SERVICE PARTS LIST

BULLETIN NO.
54-06-0164

SPECIFY CATALOG NO. AND SERIAL NO. WHEN ORDERING PARTS		REVISED BULLETIN	DATE
1/2" MAGNUM HOLE-SHOOTER		54-06-0163	Apr. 2010
CATALOG NO. 0234-6	STARTING SERIAL NO. 532D	WIRING INSTRUCTION	
		58-01-1651

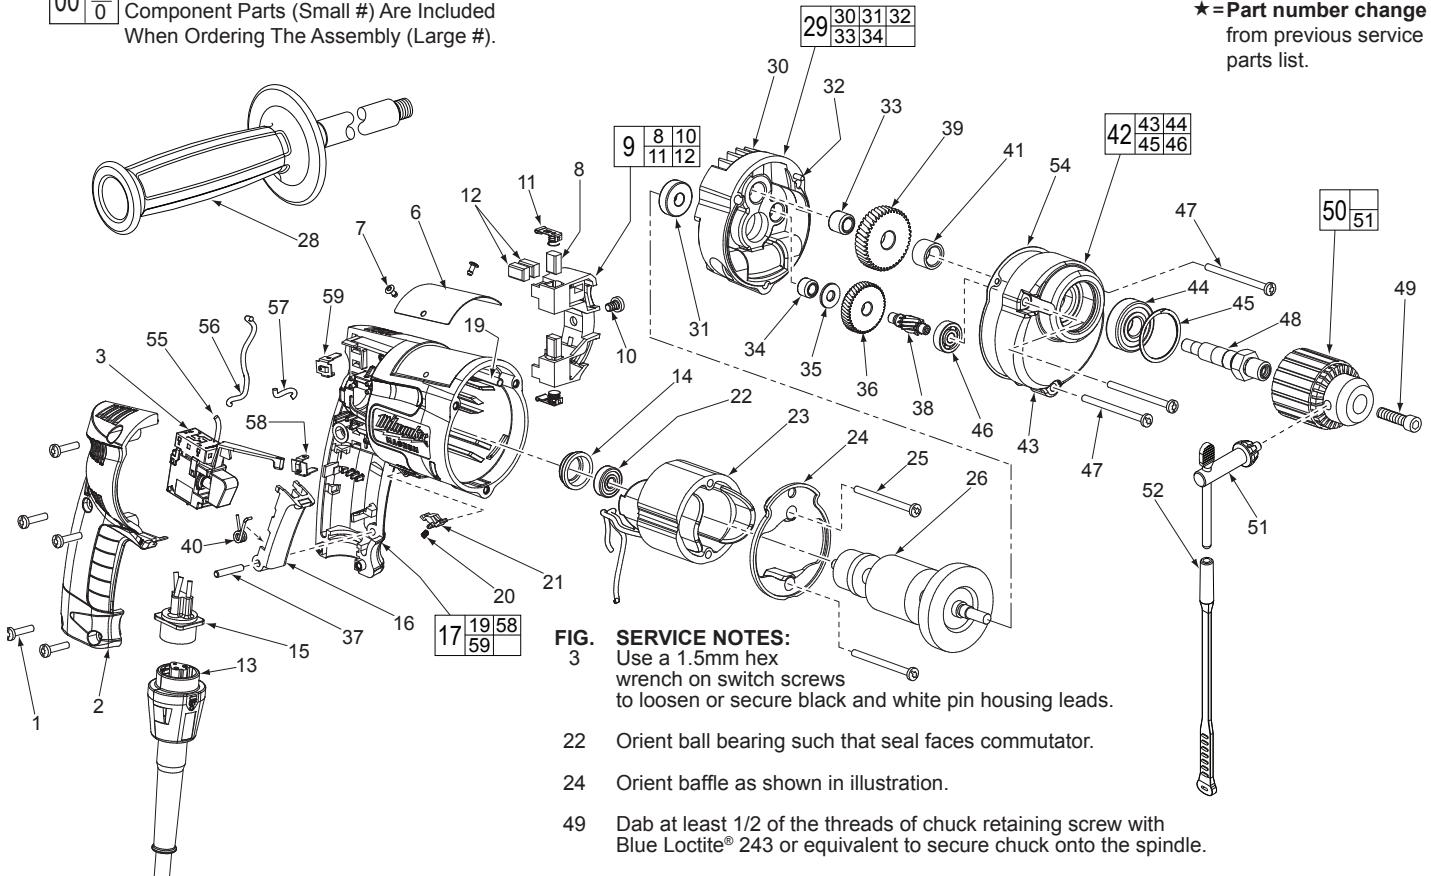
★ = Part number change
from previous service
parts list.

FIG.	PART NO.	DESCRIPTION OF PART	NO. REQ.	FIG.	PART NO.	DESCRIPTION OF PART	NO. REQ.
1	06-82-7266	7-1/8 x 11/16" Pan Hd. Plastite T-20	(5)	38	36-66-4261	Intermediate Pinion	(1)
★ 2	31-15-0405	Handle Cover	(1)	39	32-75-2911	Spindle Gear	(1)
★ 3	23-66-1705	Trigger Speed Control Reversing Switch	(1)	★ 40	40-50-0525	Torsion Spring	(1)
★ 6	12-99-0077	Nameplate Blank	(1)	41	45-36-1100	Spacer	(1)
7	06-72-1720	Nameplate Rivet	(2)	42	14-30-0337	Gearcase Assembly	(1)
★ 8	22-16-0295	Carbon Brush	(2)	43	-----	Gearcase	(1)
★ 9	22-22-0352	Brush Holder Assembly	(1)	44	02-04-1229	Ball Bearing	(1)
★ 10	23-44-0200	Brush Holder Screw	(1)	45	34-80-2300	Retaining Ring	(1)
11	22-20-0345	Brush Spring Assembly	(2)	46	02-04-0640	Ball Bearing	(1)
★ 12	22-16-0295	Carbon Brush (Spares)	(2)	47	06-82-7411	7-18 x 2-3/16" Pan Hd. Plast. T-20	(3)
13	48-76-4008	Quik-Lok Cord Set	(1)	48	38-50-5251	Spindle - Double Reduction	(1)
14	22-72-0100	Bearing Cup	(1)	49	06-75-3150	1/4-20 x 1" Skt. Hd. Screw-L.H.Thd.	(1)

★ 15	22-56-0845	Pin Housing Assembly	(1)	50	48-66-1360	1/2" Chuck	(1)
★ 16	45-72-0085	Trigger	(1)	51	48-66-3280	Chuck Key	(1)
★ 17	14-38-0541	Motor Housing Assembly	(1)	52	48-66-4040	Key Holder	(1)
19	44-60-1290	Grounding Pin	(1)	54	43-44-0913	Gasket	(1)
20	40-50-0085	Lock Button Spring	(1)	★ 55	23-94-6248	Leadwire Assembly, Blue	(1)
21	42-42-0460	Lock Button	(1)	★ 56	23-94-6336	Leadwire Assembly, Black	(1)
22	02-04-0645	Ball Bearing	(1)	★ 57	23-94-6405	Leadwire Assembly, White	(1)
★ 23	18-11-0076	120 Volt Field	(1)	★ 58	23-74-1030	Terminal, Lower	(1)
★ 24	42-14-0393	Baffle	(1)	★ 59	23-74-1040	Terminal, Upper	(1)
25	06-82-7398	7-18 x 2-1/16" Pan Hd. Plast. T-20	(2)	★	10-98-5996	Warning Label (Not Shown)	(1)
★ 26	16-10-0801	120 V. Armature Assembly	(1)				
★ 28	43-62-0886	Side Handle Assembly	(1)				
★ 29	14-13-0499	Diaphragm Assembly	(1)				
30	-----	Diaphragm	(1)				
★ 31	02-04-0851	Ball Bearing	(1)
